Hannover House - Response to LPA comments

Photographs & Diagrams to assist discussion

FIRST FLOOR EXISTING

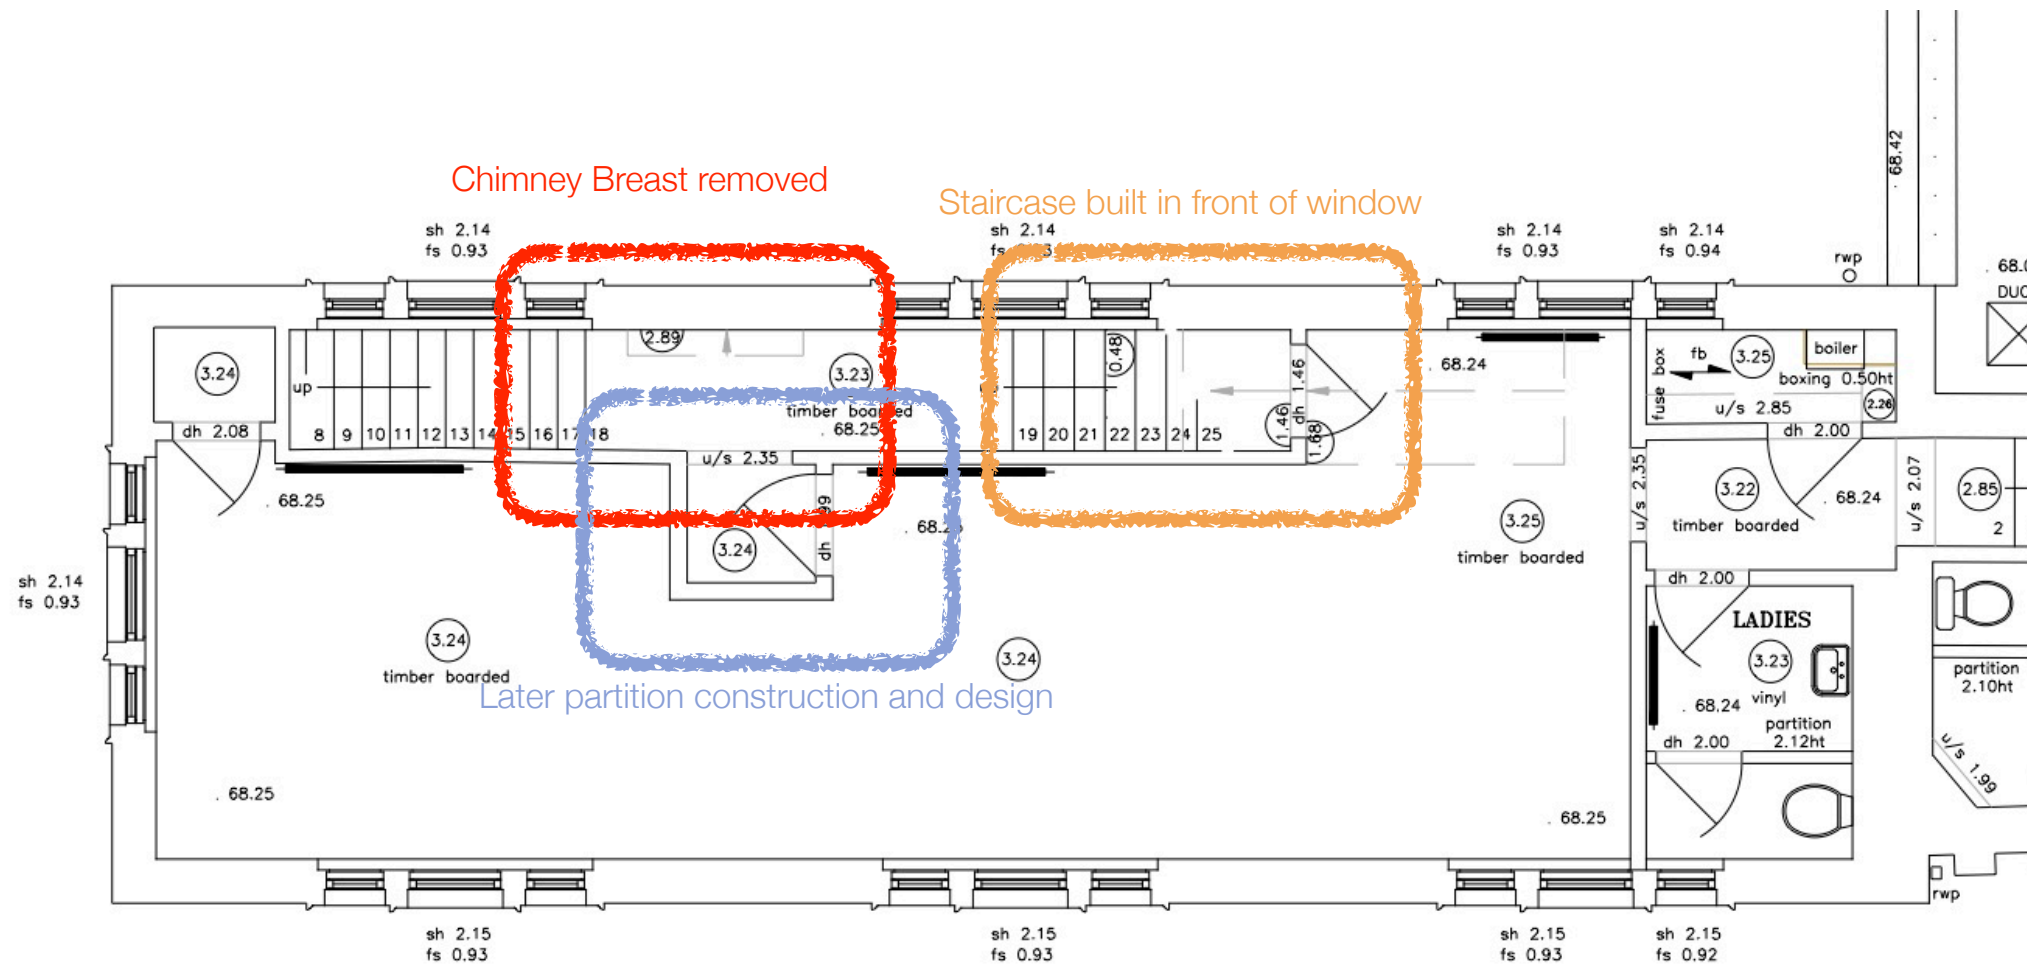
Staircase enclosure linked to wc construction
built in front of fireplace = not original

Later staircase partition construction and design

Staircase built in front of window
an unlikely original detail by any architect

Later staircase partition construction and design first floor

SECOND FLOOR EXISTING

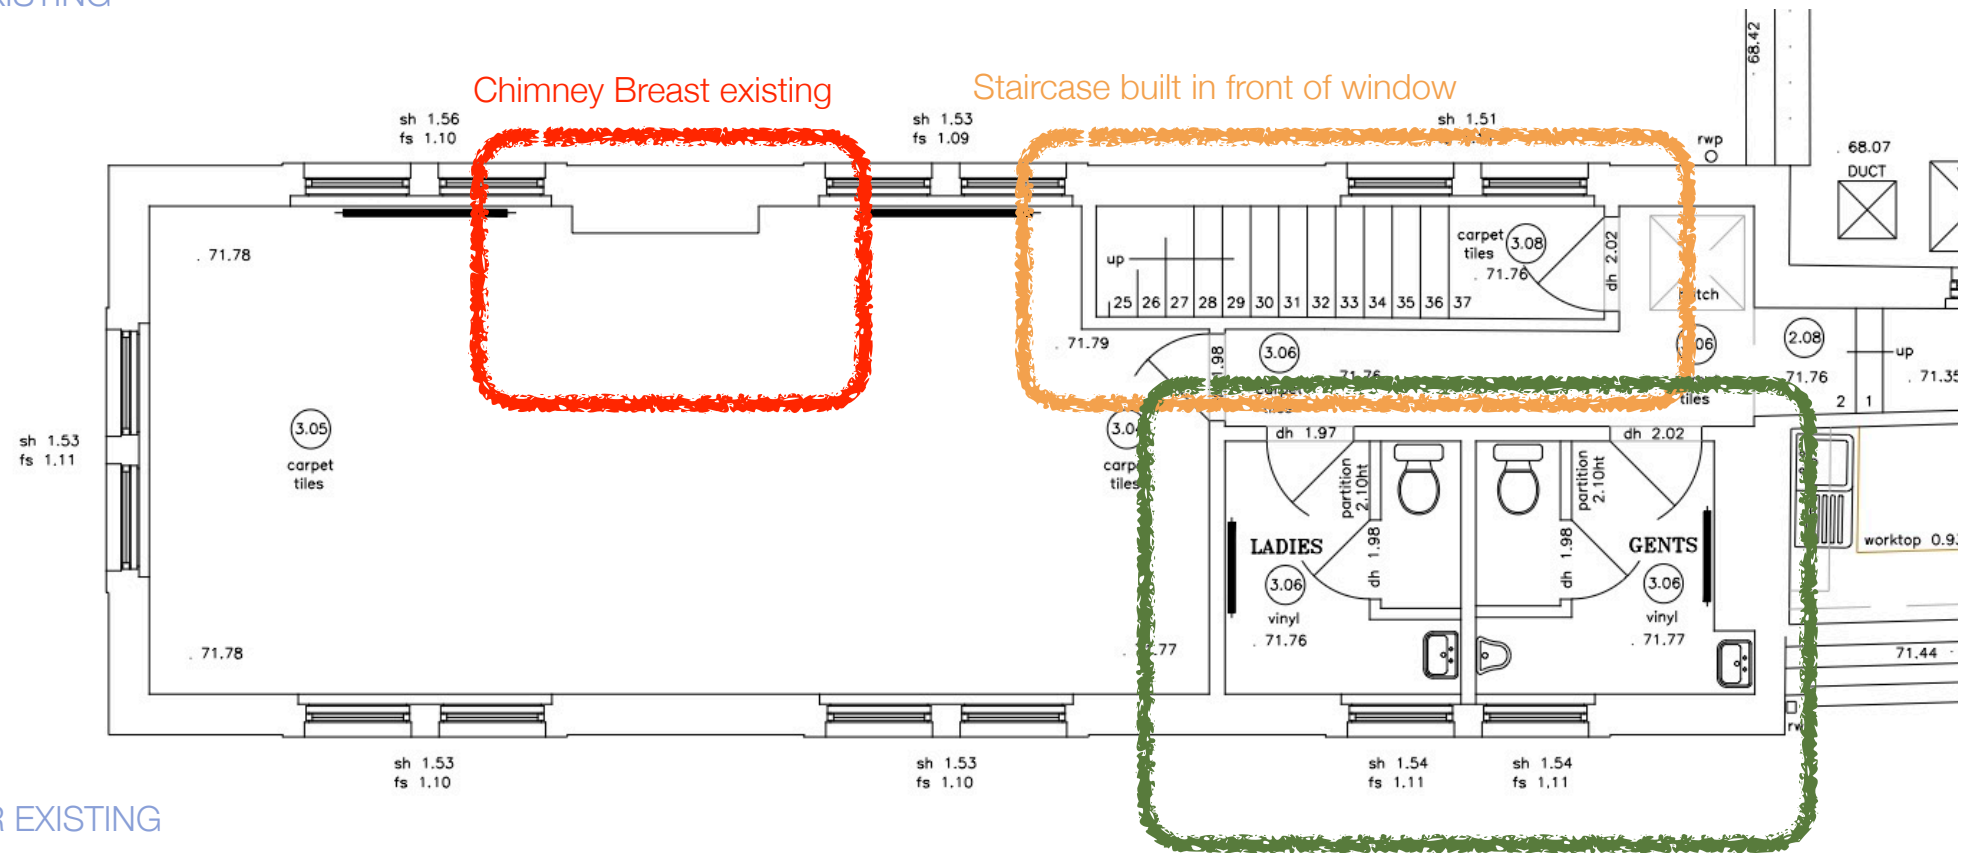
Chimney breast second floor

Staircase enclosure linked to wc construction second floor

Later staircase partition construction and design Second Floor
